Post Exhibition Planning Report

The purpose of this document is to provide a summary of the submissions received following the exhibition of the draft precinct planning documents for Riverstone West in March 2009.

Figure 8: Environmental corridor showing Core Riparian Zone, Vegetated Buffer and vegetation offsets.

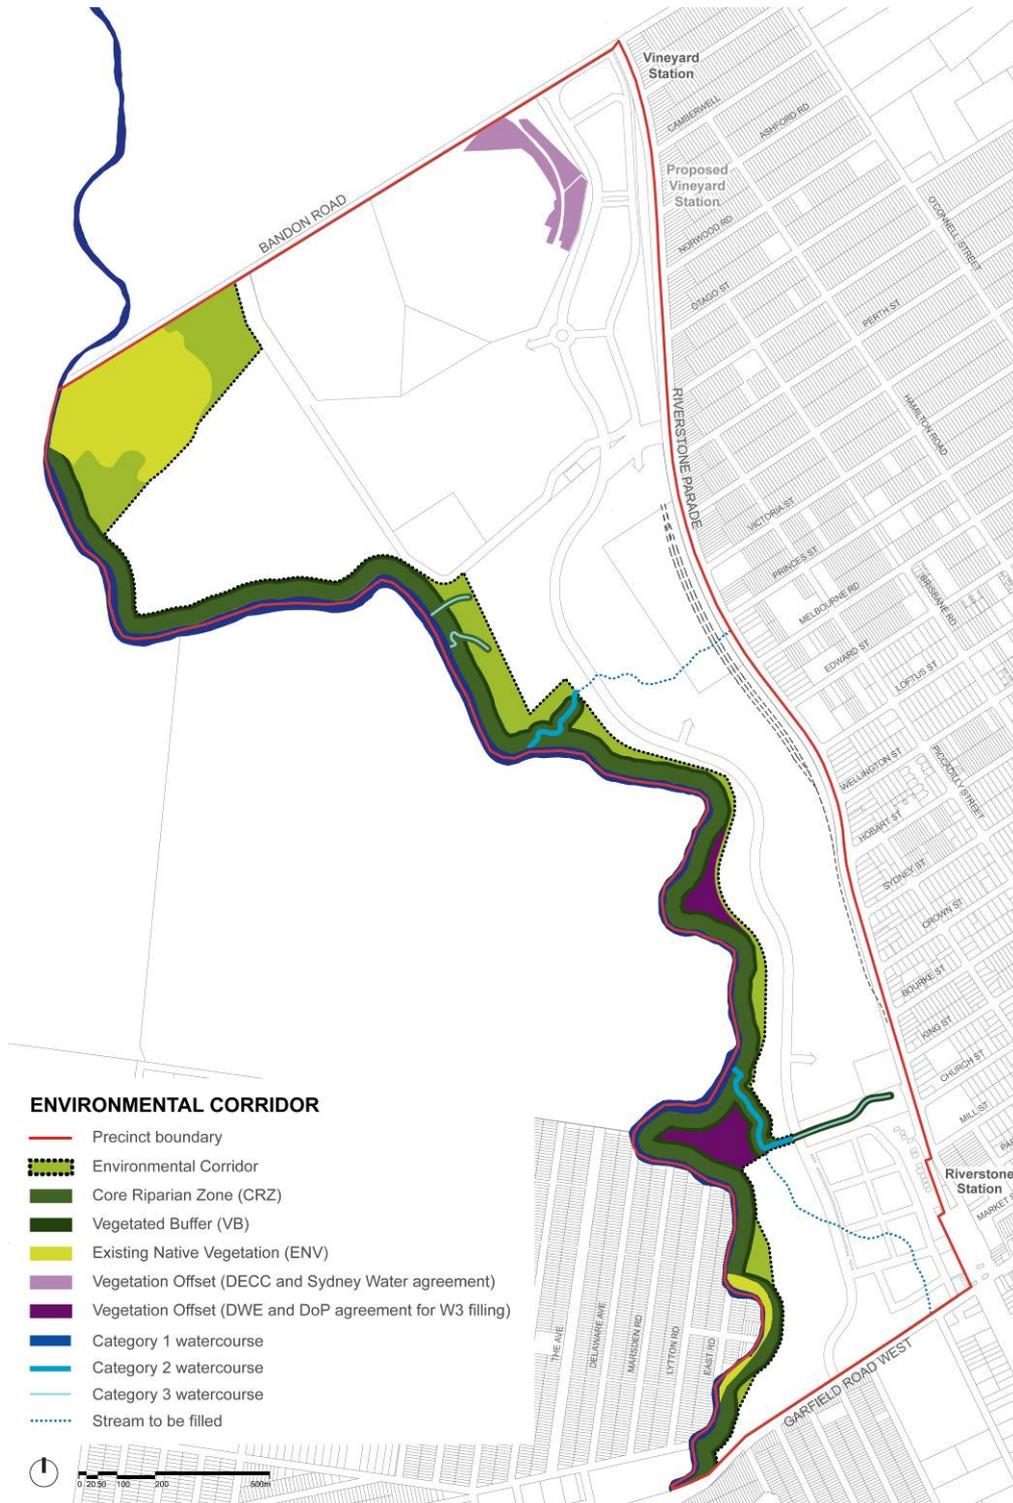
In response to DWE's request to distinguish the CRZ and VB from adjacent open space areas, Figure 26 of the DCP, showing the Riverstone West environmental corridor has been amended to clearly show the CRZ and VB within the environmental corridor. Uses appropriate within each of these areas are detailed in the NWGCWLS. **Figure 8** of this report provides further details regarding the vegetation offsets required by DECC and DWE.

With the agreed to the partial filling of stream W3, DWE requests details on the 2.4 hectares of offset area which is to be located beyond the riparian corridor.	I18-1 The 2.4 hectare offset area will be provided in the E2 Conservation zone beyond the riparian corridor. The WLS for Riverstone West will identify appropriate location of specific uses. Refer to Figure 2 of the Post Exhibition Planning Report.
--	--	---	---
